**PUBLIC NOTICE**  
**PLANNING AND ZONING BOARD MEETING – October 12, 2020**

**To:** Planning and Zoning Board Members  
**CC:** Bea Meeks, City Clerk  
Drew Smith, City Attorney  
Allen Lane, City Engineer  
David Mahler, City Engineer  
**From:** Sandy Riffle, Deputy City Clerk  
**Date:** October 7, 2020  
**Re:** New Business Items

Date: September 19, 2020  
 To: Planning and Zoning (P&Z) Board  
 From: Ellen Hardgrove, City Planning Consultant  
 XC: Sandy Riffle, Deputy City Clerk  
 Bea Meeks, City Clerk  
 Drew Smith, City Attorney  
 Allen Lane, CPH Engineering, City Engineering Consultant  
 Jim Winter, CPH Engineering  
 Re: Suncoast Special Exception Amendment and Variance Requests

Date: September 29, 2020  
 To: Planning and Zoning (P&Z) Board  
 From: Ellen Hardgrove, City Planning Consultant  
 XC: Sandy Riffle, Deputy City Clerk  
     Bea Meeks, City Clerk  
     Drew Smith, City Attorney  
     Allen Lane, CPH Engineering, City Engineering Consultant  
 Re: Proposed Preliminary Subdivision Plan of Lot 19, Oak Lynn Second Plat: 429 Oak Lynn Drive

# Plan View

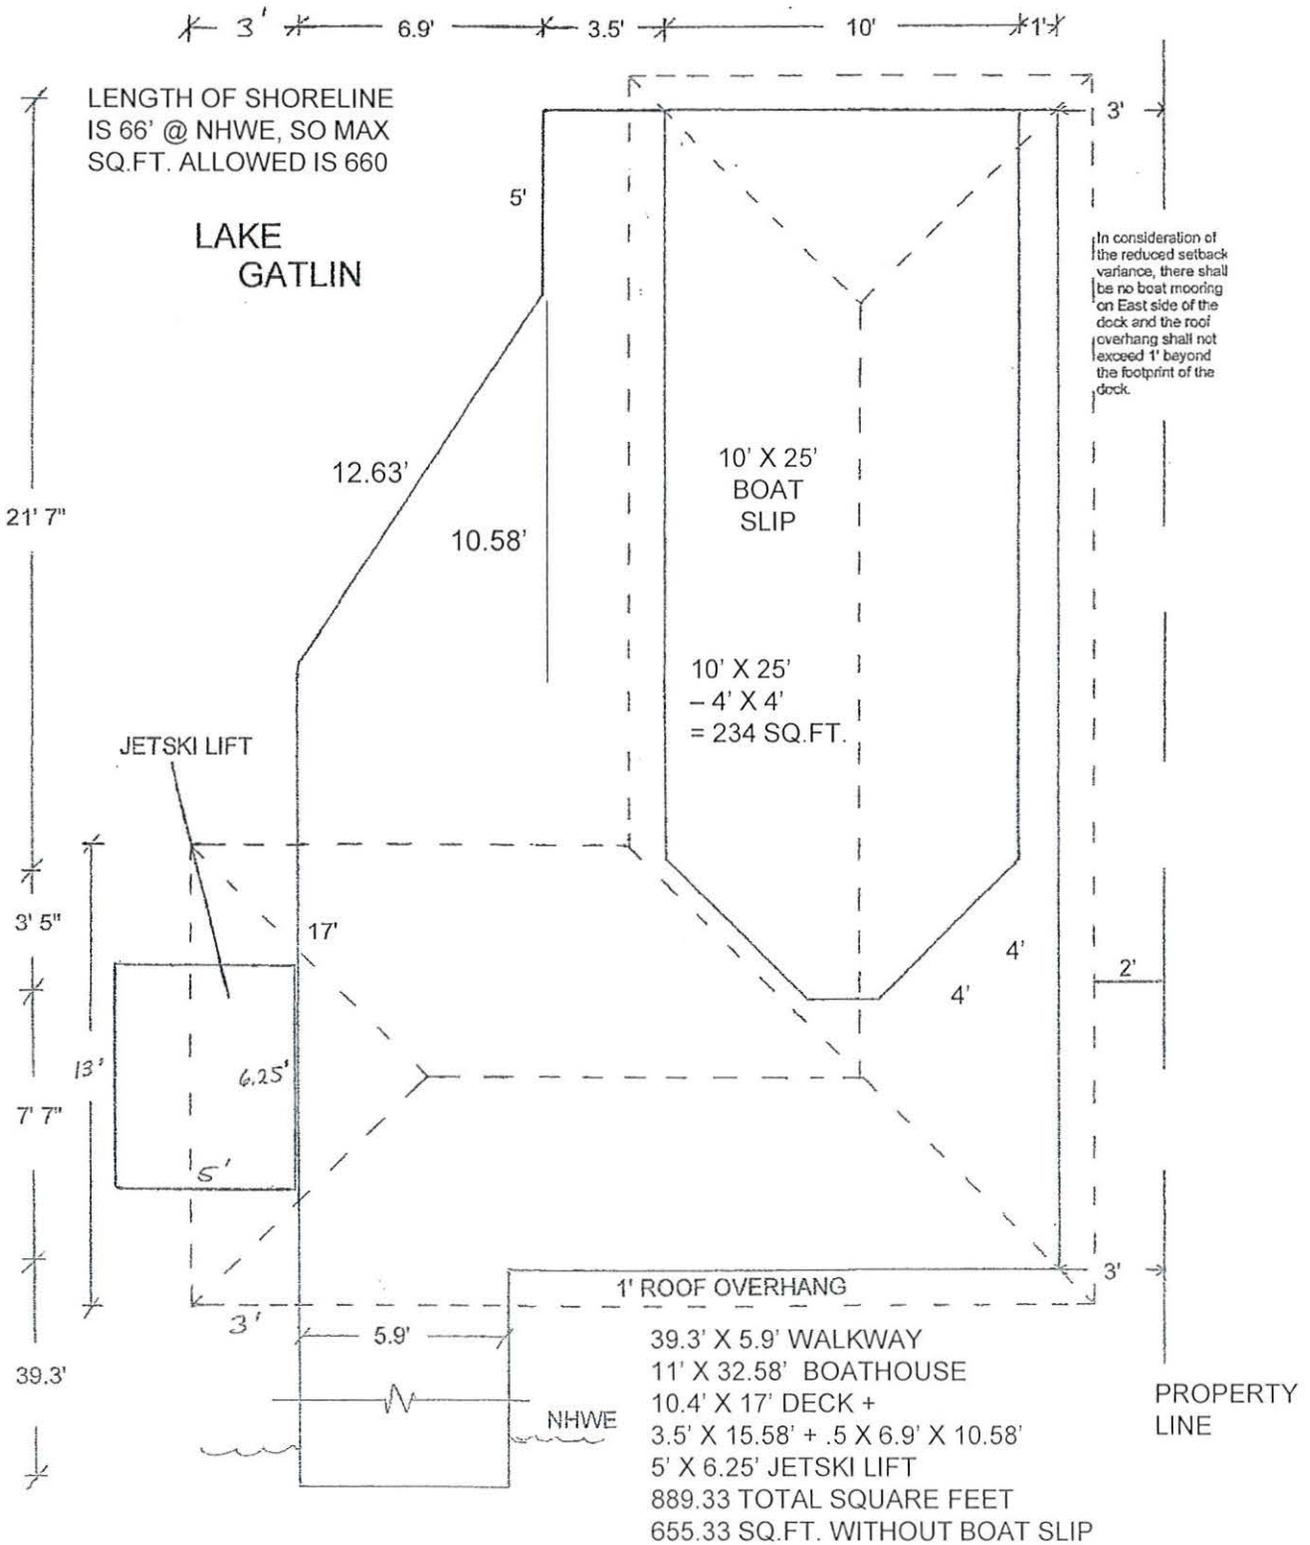
The west side of the dock deck will encroach by 4 feet, per the plan. The distance will be 11 feet from the west property line.

The east side of the dock deck will encroach by 12 feet, per the plan. The distance will be 3 feet from the east property line.

The Plan View shows a dimension of three (3) feet from the property line to the edge of the dock platform and a dimension of two (2) feet from the property line to the edge of the roof overhang, indicating the roof overhang will not be greater than one foot beyond the edge of the dock. The Plan View includes a note referencing the boat mooring requirement. Therefore, as a condition of approval, the roof for the boat house may not extend more than one foot beyond the edge of the dock. Also, as a condition of approval, there shall be no boat mooring on the east side of the dock.

Exhibit 2 – Approved Landscape Plan

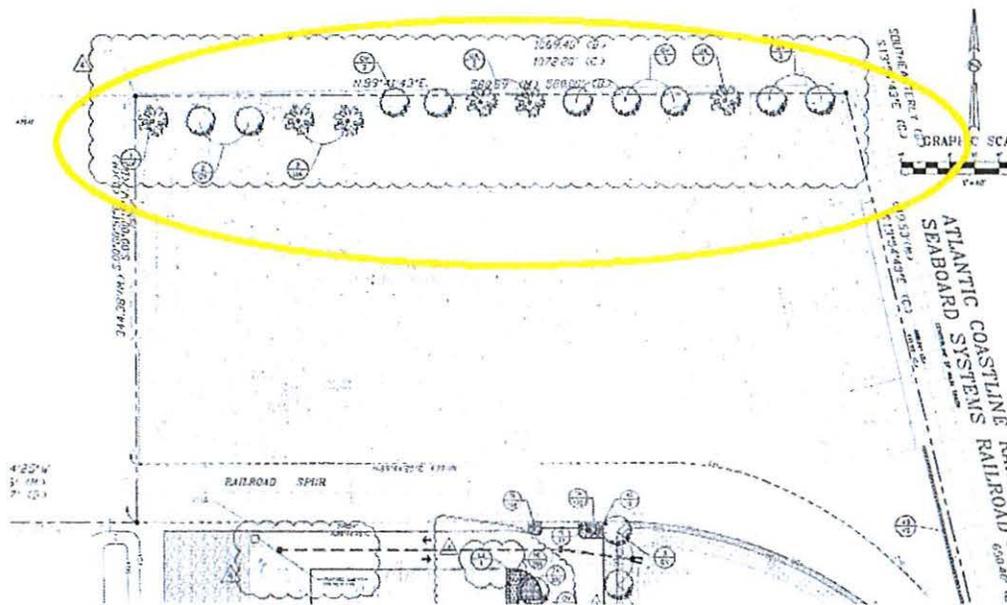
As copied to Exhibit 2, the approved 2018 landscape plan combined the requirement for the 25 feet high landscape screening with the requirement for the required row of trees. The trees on the site plan are planned at a rate of 1 tree per ±38.5 lineal feet.

Exhibit 3 - July 2020 Proposed Buffer Adjacent to the Residential

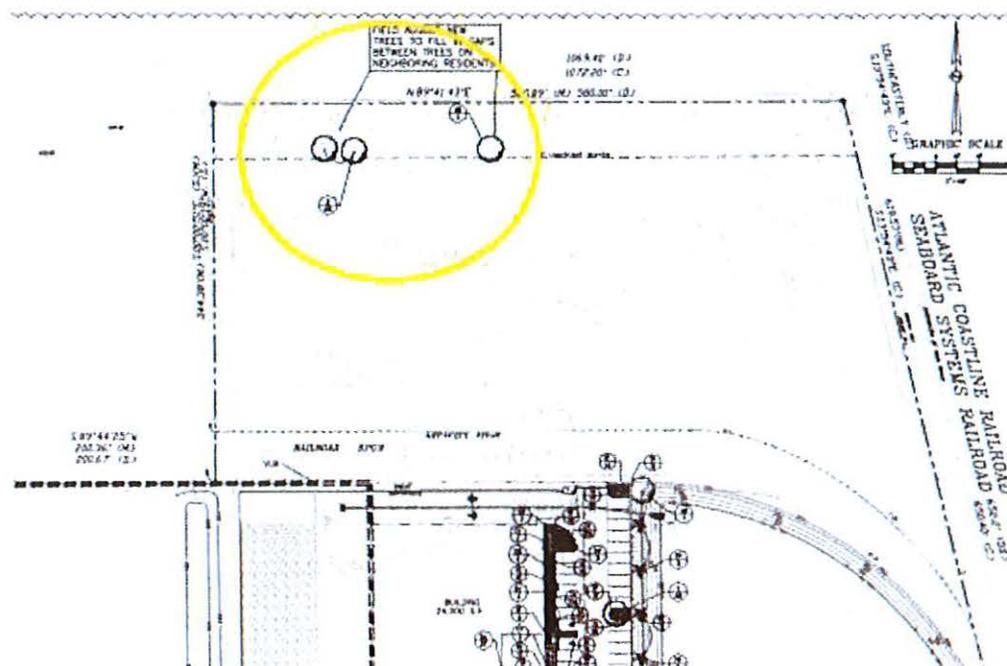
As per Exhibit 3, the applicant is proposing to not plant the landscaping along the wall, instead to only plant three (3) trees ±50 feet south of the wall, which is a rate of 1 tree per 193.63 lineal feet. Thus, in addition to proposing to eliminate the special exception condition of providing a dense continuous landscaping between 8 and 25 feet in height above grade, the applicant is requesting a variance to allow the reduction in rate of tree provision.

The request to eliminate the dense evergreen landscape screen along the wall is contrary to the intent to ensure land use compatibility when approving special exceptions (Code Section 134-104), particularly related to visual, noise, and air quality impacts of the approved use. The photos in Exhibit 4 show that while there are existing trees on the residential lots, the three proposed trees do not fill in the gaps to provide a screen up to 25 feet in height.

Staff recommends denial of the change to the special exception condition of approval. A dense evergreen screening at least 25 feet in height above grade is necessary. This recommendation for denial in effect is a recommendation for denial of the requested variance to reduce the rate of trees to be planted in the buffer.

**Exhibit 11 – Need for Trees along Southern Building Façade**

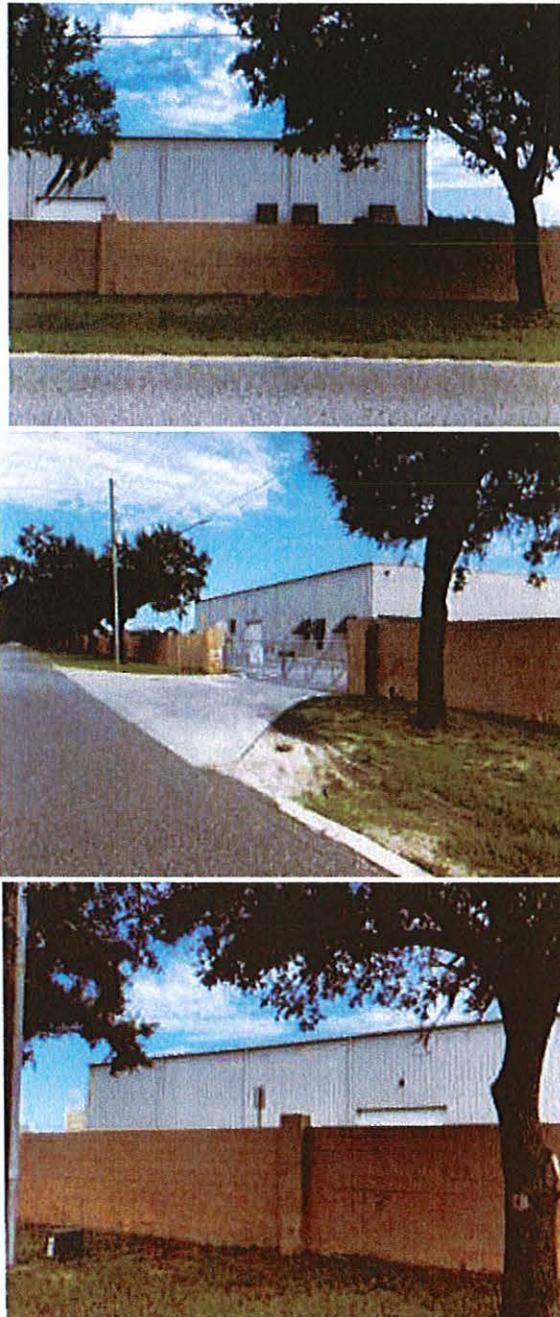
As shown by Exhibit 11, the required trees will be able to be seen from Mary Jess Road and would help to break up the mass of the building.

In addition to viewers along the road, the intent of building perimeter landscaping is visual appeal and aesthetics for workers and customers, environmental benefits for heat and air quality, as well as improves property values. As seen on the site plan, the site design does not preclude or prohibit the ability to provide the required landscaping. Special circumstances do not exist and other properties would be required to provide the building perimeter landscaping.

**Exhibit 12 – Shade Trees vs Palm Trees**

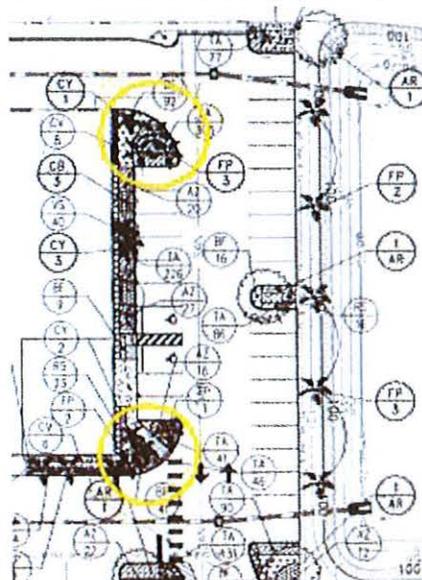
The applicant is requesting the ability to swap the required shade trees within the parking area east of the building with palm trees as circled in Exhibit 12.

The applicant's rationale for the swap is that 1) the parking lot is small, 2) palm trees were used in the prior use (though were removed with the construction of the existing building) and 3) to avoid conflict with truck traffic. This rationale does not meet the 6 criteria for variance approval.

Exhibit 2 – Proposed Subdivision into Three Lots

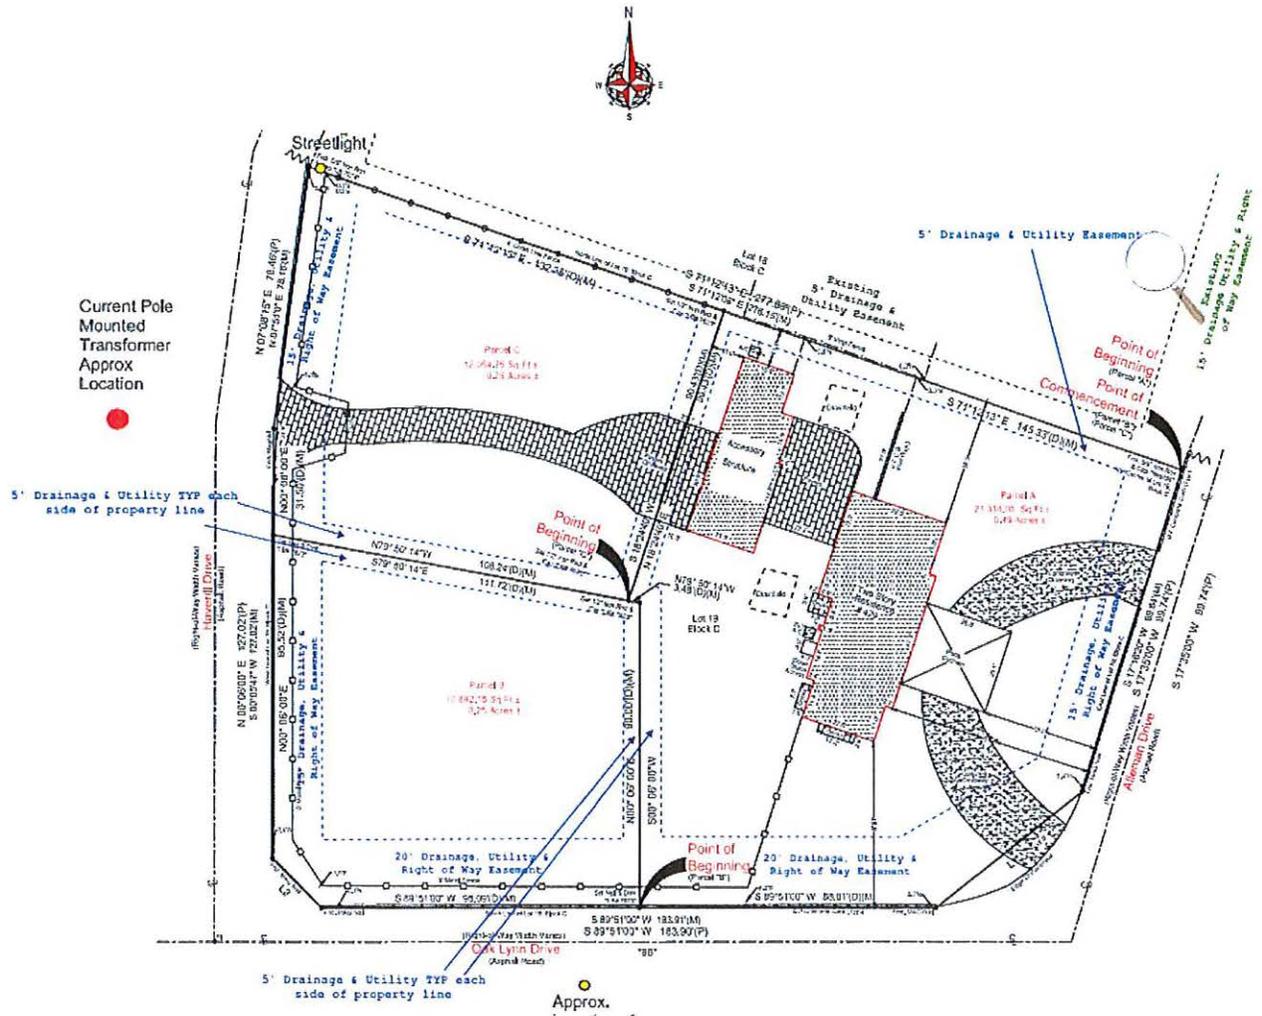
The subject property is ±1.02 acres and currently contains a two story house oriented toward Alleman Drive and an accessory structure as shown. Three lots are proposed to be created as shown in Exhibit 2.

Exhibit 3 – Substandard Right-of-way in Plat

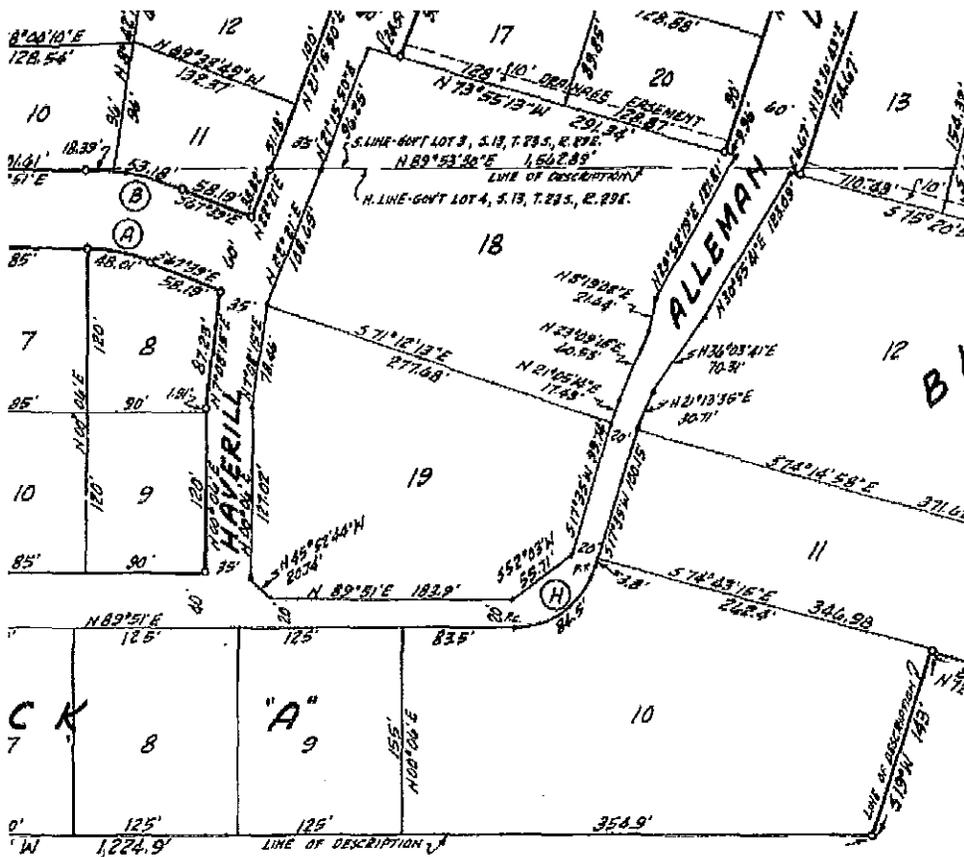
The Oak Lynn Second Plat was platted in the City in August 1958. It was created from property that contained existing homes. The rights-of-way adjacent to the lots with the existing homes, which included the subject property, were allowed to be substandard in width, with Oak Lynn and Alleman Drives at 20 feet in width and Haverill Drive at 35 feet as shown in Exhibit 3.

A note on the plat states, “the 20 feet rights of way of Oak Lynn Drive and Alleman Drive opposite Lots 9, 10, 11, and 12, Block “A” and Lots 18 and 19, Block C do not meet the town of Edgewood’s requirements and such portion of said streets is accepted for recording purposes only.” The substandard right-of-way of Haverill Drive is not mentioned on the plat, and given the plat layout, is considered a half street.

Exhibit 4 – Oak Lynn Estates (North of the subject property)

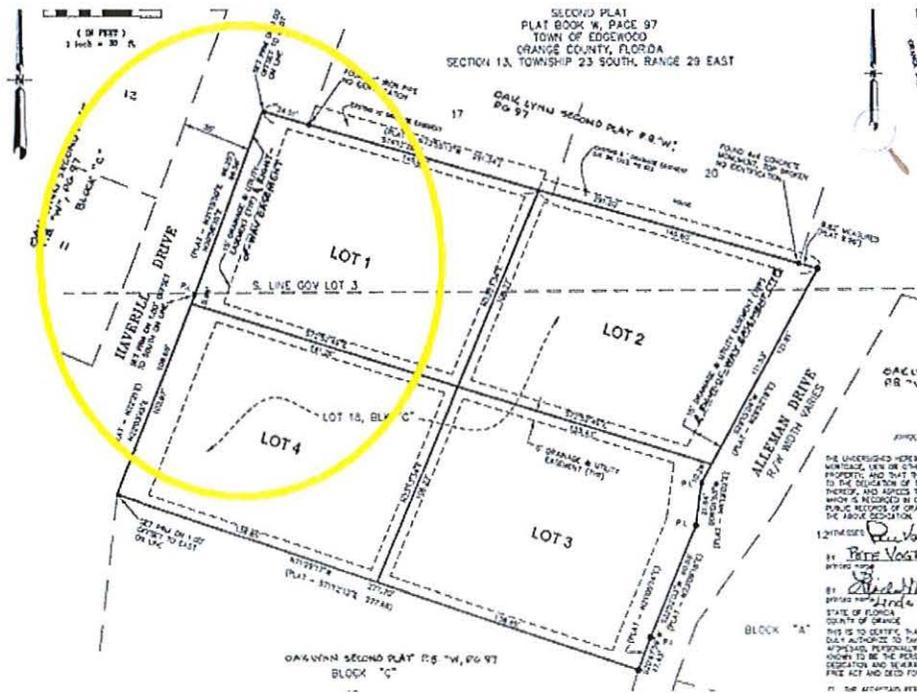
For the variance to the right-of-way width required for Haverill Drive, these criteria are met.

It would be impractical to provide 25 feet from the subject property to create a 60 feet wide Haverill Drive right-of-way given only 15 feet was required for the Haverill Drive right-of-way when the Oak Lynn Estates subdivision was approved in 2001 (formerly lot 18 of the Oak Lynn Second Plat Subdivision) as shown on Exhibit 4. As was determined in 2001, 50 feet of right-of-way for Haverill Drive is sufficient to accommodate future public needs, and denial of the request would deprive the applicant rights commonly enjoyed by other properties in the neighborhood. The conditions and circumstances that exist for this property were not the result of the applicant.
